From: [REDACTED]
To: [Federal Street](#)
Subject: Comments on Federal Street Residences, Fast Track Application: RL Senojak & Others
Date: Sunday, 3 April 2022 11:39:28 am
Attachments: [REDACTED]

Contact details	The Rana Senojak Family Trust	[REDACTED]
First Name	Rana	
Last Name	Senojak	
Postal Address	[REDACTED]	
Phone	[REDACTED]	
Email	[REDACTED]	
	I can receive emails and my email address is correct	
Comments	<p>We have no issue with the project, however we do have concerns about the following items and how these will be mitigated.</p> <p>Response from and discussion with the Developers will help</p>	
	<p>Please see comments and related document content below. These are provided to address the following:</p> <ul style="list-style-type: none"> • Potential impact on the Tenant • Risk of potential costs the 'Altitude' Body Corporate and/or Owners" may incur during and after the development 	
Legal cost	<p>There are several sections mentioning that affected parties (Altitude) should seek legal advice.</p> <p>As this is a cost directly related to the project (Federal Street Residences), we believe this should be at the cost of the Developer and the legal (and other) representative(s

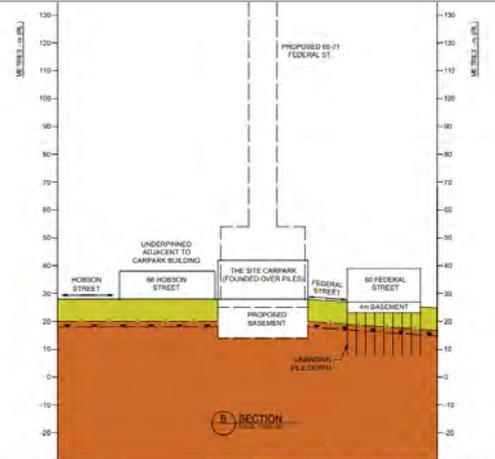
Altitude is not as deep - how will this be protected

Figure 3: Concept image of the Proposed Development

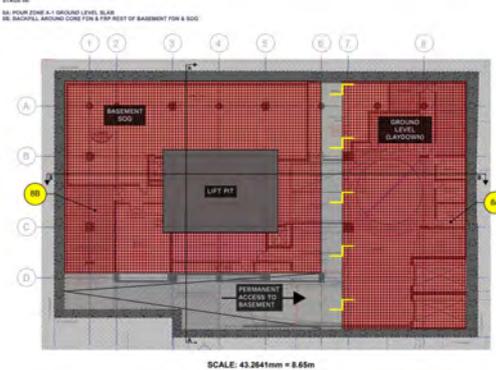
Which if any apartments will be affected by loss of the eastern windows.

- It is not immediately apparent which eastern wall apartments will lose the eastern wall windows due to the height of the adjoining podium wall
 - Is it the same as current or will it be higher?
 - From this image it looks like it will impact up to Level 11 of Altitude which is higher than current
 - How will water ingress be controlled, that is will the walls abut or will there be a gap
